Volume III: Public Participation Report

Proposed Emvelo Wind Energy Facility and Associated Grid Infrastructure, near Ermelo, Mpumalanga

FINAL FOR DFFE DECISION

25 August 2025

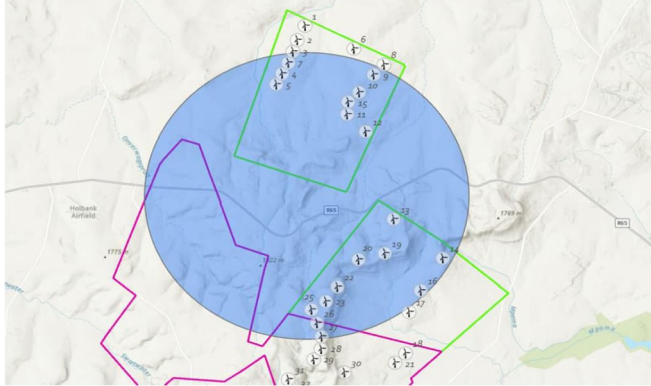
Statistical Flaws in the Model: The flight risk model created using machine learning combined coarse-scaled GPS data across a wide area with fine-scaled, dense flight path data from a very limited area (majority within 2 km of nest) (see Figure 18 in the avifaunal assessment). Incorporating detailed, fine-scaled observational flight paths from such a limited area introduces spatial bias, where model output is disproportionately influenced by the more detailed sampling from the fine-resolution area, leading to overrepresentation of that smaller region. This approach is statistically flawed when differences in spatial area, resolution, sampling intensity, and density are not properly accounted for. This violates spatial statistical assumptions, resulting in inconsistent variance estimates, inaccurate predictions, and biased interpretations that do not accurately reflect broader spatial patterns.	While we acknowledge the limitations inherent in working with a small sample size — which is a known challenge for this species — the modelling approach integrates multiple lines of evidence and has prioritized precaution in delineating turbine exclusion zones and mitigation areas. The intent is to implement a risk-responsive mitigation hierarchy that reduces potential collisions. Due to the limitations of the GPS data — specifically, inconsistent one-hour ping intervals — we chose to analyse bird movement using proportion of time spent within distance bands rather than flight paths or number of GPS points – see Figure 1 below. This method more accurately indicates areas where birds are at increased risk, as the duration spent within a zone serves as a more reliable metric considering the data resolution of one-hourly GPS fixes. The chart represents delta time across zones, not distance travelled or observation count, and we believe this method is the most appropriate and transparent given the data quality.

MTPA Analysis and Findings: The MTPA used the same GPS tracking data to verify whether Martial Eagles spent 75% of their recorded flight activity within 3 km of the nest but could not replicate this statistic. We calculated the distance between each GPS observation (n=7266) and the nest, we then categorised each observation into

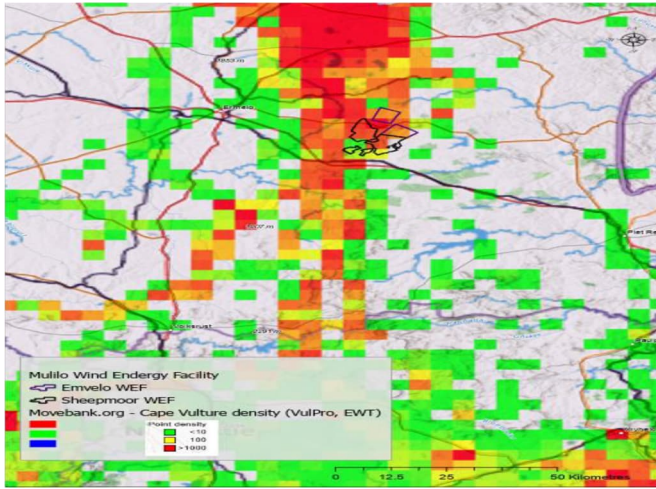
Distance from nest	Chrissy_female_adult	Erma_female_juvenile																																													
0-3km	3200	850																																													
3-5km	150	50																																													
5-7km	1200	100																																													
7-12km	500	100																																													
12-20km	700	100																																													
>20km	100	300																																													
Distance from nest	Chrissy_female_adult	Erma_female_juvenile																																													
0-3km	240	60																																													
3-5km	100	15																																													
5-7km	130	20																																													
7-12km	180	15																																													
12-20km	180	15																																													
>20km	30	90

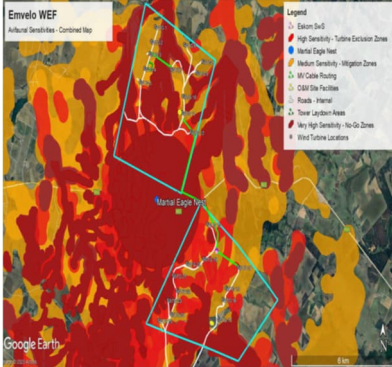
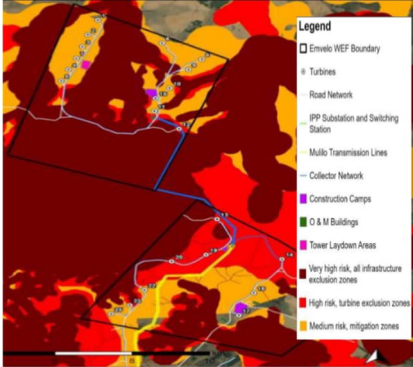
3.15.It is unclear as to what the final layout constitutes because as already noted, in the CRR the EAP makes reference to WTGs being moved in the “final layout”. The reports are plagued with inaccuracies and contradictory statements. The credibility of the assessment process is doubtful as so many uncertainties prevail. IN this regard, the following questions arise:	The EAP acknowledges the concerns regarding apparent discrepancies in references to the “final layout” across the reports. The following clarifications are provided:

Ref	Name of Organisation	Date and Method	Phase of PP	Comment	Response
				3.15.1.If as noted by the terrestrial biodiversity specialist (for example), final layout plans were provided by ERM in January 2025, then is this the layout that was assessed for the purposes of the March 2025 Draft EIA Report? This is not clear at all from the reports made available to I&APs.	The layout assessed in the March 2025 Draft EIA Report was based on the January 2025 layout provided by ERM, which represented the preferred arrangement of turbines and infrastructure at that time. While this layout served as the reference for the environmental assessments, it is acknowledged that the final layout remains subject to micro-siting refinements following on-site verification and specialist input. Therefore, the March 2025 Draft EIA accurately assessed the environmental sensitivities of the layout available at that stage, with any subsequent adjustments clearly documented in the July 2025 Draft EIA Report.

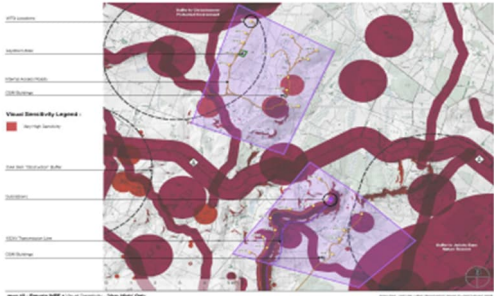
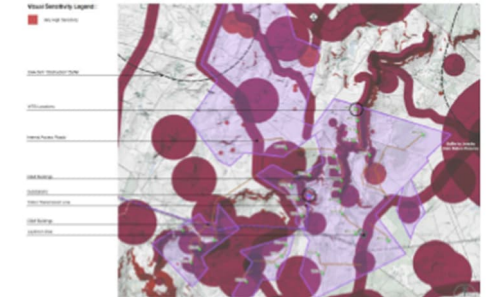
8.4. The viewsheds in both VIAs are based on a turbine hub height of 150 meters. According to the peer review by Winter and Lawson (2025), attached hereto, a rotor tip height of 260 meters is generally required to be used for the calculation of viewsheds for wind turbines and which results in a far more extensive geographic area being affected by the proposed turbines. The viewsheds for both WEFs have therefore been significantly under-reported on and underestimated in the VIAs. In this regard, see the below maps with respect to the Emvelo WEF. The first map represents the sequential visibility of the wind turbines with a hub height of 150 meters, whereas the second map represents the sequential viewshed of wind turbines with a rotor tip height of 260 meters and the third map represents the distance-based viewshed of wind turbines with a rotor tip height of 260 meters:	The viewsheds in both VIAs is based on the height of the turbines as noted on pg. 31 of both reports (hub height at 150 metres and rotors of 110 metres). “Although, due to the nature of land (topography, grassland vegetation, agriculture, timber, and settlements) immediately adjacent and in the general vicinity of the site, the landscape, although reasonably flat to undulating, provides a low visual absorption capacity (VAC). This is due to the substantial height of the turbines (maximum 250m to tip of rotor blade), the nature of the vegetation cover. The landscape is therefore not readily able to ‘absorb’ the visual change.” Using the rotor tip height of 260 metres, will give a false impression (over reporting) of the theoretical visibility of the turbines as at that off-set reading only the very tip of the turbine would be visible. We always include a lower offset to give a more realistic sense of visibility. It must also be noted that viewsheds are theoretical and not absolute

Ref	Name of Organisation	Date and Method	Phase of PP	Comment	Response
				Viewshed Visibility Highly Visible Medium Visible Marginally Visible Not Visible  8.5 Furthermore, see the below maps with respect to the Sheepmoor WEF. The first map represents the sequential visibility of the wind turbines with a hub height of 260 meters, whereas the second map represents the sequential viewshed of wind turbines with a rotor tip height of 150 meters and the third map represents the distance-based viewshed of wind turbines with a rotor tip height of 260 meters:

Ref	Name of Organisation	Date and Method	Phase of PP	Comment	Response
					as they do not include vegetation or structures in the modelling (stated in Figure 7-2 of both reports). Using this method does however, give a reliable indication of the overall visibility and exposure of the project, which for both projects, is indicated as high intrusion and exposure (Figures 7-2 and Section 9.5 in both reports). The rating is based on the worst case scenario, which is assessed in the reports.
